# Access Compliance Report

### (Curb Ramps)

Intersection ID: 3735	Main Street: DAVIS_LAKE_PY	Cross Street: FOXBRIAR_TL	Location: SE
ADA ID: 11EE8C5831C5	Ramp Type: Perp	Initial Pass/Fail: Fail	Overall Compliance: No
Severity Score: 13.75			
Codes/Mitigation Info/Possible Solution		Field Measurements/Component Compliance

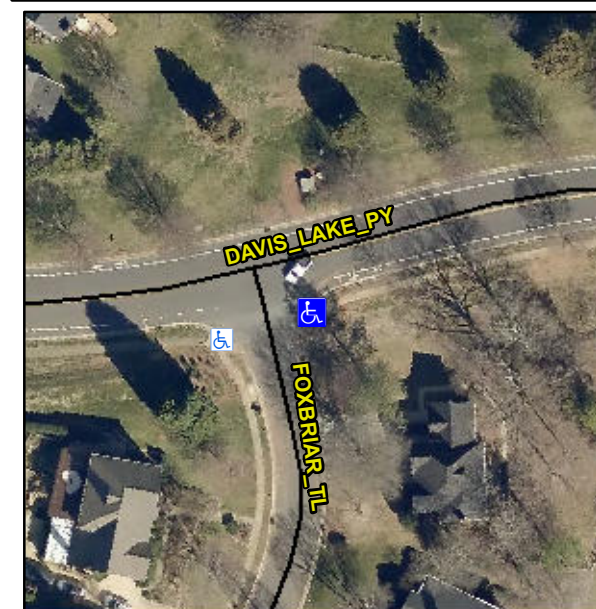
**Remove & Replace Entire Ramp.**

**Not Found, R304.2.2, R304.5.3**

Compliance	Description	Data	Compliance	Description	Data
N/A	Ramp Length (in)	46.0	No	Ramp Slope (%)	9.1
Yes	Ramp Width (in)	48.0	No	Ramp XSlope (%)	2.3
N/A	Flare Type LT	N/A	N/A	Flare Type RT	N/A
N/A	Flare Slope LT (%)	N/A	N/A	Flare Slope RT (%)	N/A
N/A	Flare Traversable LT?	N/A	N/A	Flare Traversable RT?	N/A
N/A	Landing Length (in)	N/A	N/A	DWS Provided?	N/A
N/A	Landing Width (in)	N/A	N/A	DWS Contrast?	N/A
N/A	Landing Slope (%)	N/A	N/A	DWS Length (in)	N/A
N/A	Landing X Slope (%)	N/A	N/A	DWS Full Width?	N/A
N/A	Landing Curb? (Y/N)	N/A	N/A	DWS Offset (in)	N/A
N/A	Shared Landing?	N/A			
N/A	Gutter Ponding?	N/A	N/A	Gutter Slope (%)	N/A
N/A	Gutter Lip Ht (in)	N/A	N/A	Gutter X Slope (%)	N/A
N/A	Painted X Walk1?	No	N/A	Painted X Walk2?	N/A
	X Walk 1 Direction	To W		X Walk 2 Direction	N/A
N/A	X Walk 1 Width (in)	N/A	N/A	X Walk 2 Width (in)	N/A
	X Walk 1 Slope (%)	4.5		X Walk 2 Slope (%)	N/A
	X Walk 1 X Slope (%)	8.2		X Walk 2 X Slope (%)	N/A
